From: Info
Sent: Friday, 29 September 2023 11:04 AM
To: Council Northernbeaches Mailbox
Subject: DA2022/2246 206 Hudson Parade CLAREVILLE NSW 2107

Project No.: 2023-138

Assessment of geotechnical report for proposed new dwelling
at 206 Hudson Parade, Clareville.

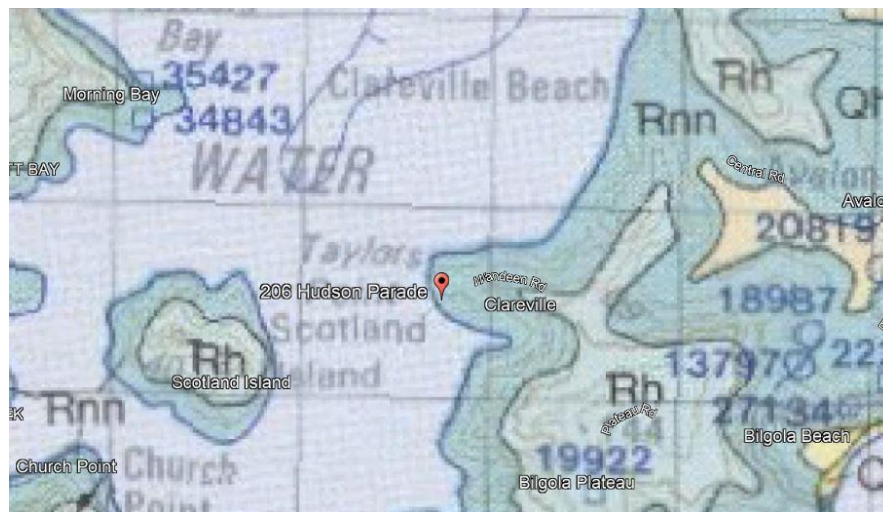
The safe batter slopes detailed in Table 2 of the report are considered reasonable for the geological units listed in that table. The report then details that “Based on proposed setbacks and depth of excavation as mentioned in Section 1.2m, we assessed that temporary batters recommended in Table 2 are applicable for proposed majority excavation of Proposed Lower levels and swimming pool”.

It subsequently details that “if excavation using safe excavation batter above is not feasible for excavation along site side boundaries due to inadequate setback” that alternative options should be implemented including reinforced shotcrete, raking or inclined shores, or a line of closely spaced/contiguous piles.

The Safe Excavation Batters listed are reasonable for the geological units listed in the report, however for excavations of >3.0 m depth continuous batter slopes in soils or weak rock are generally unsafe. Also, when considering the high potential that the geological sequence varies from that indicated in the report, along with the significantly increased excavation depths indicated, it is considered that these safe batter slopes are not possible in many locations with respect to boundary stability, and therefore pre-excavation support is needed.
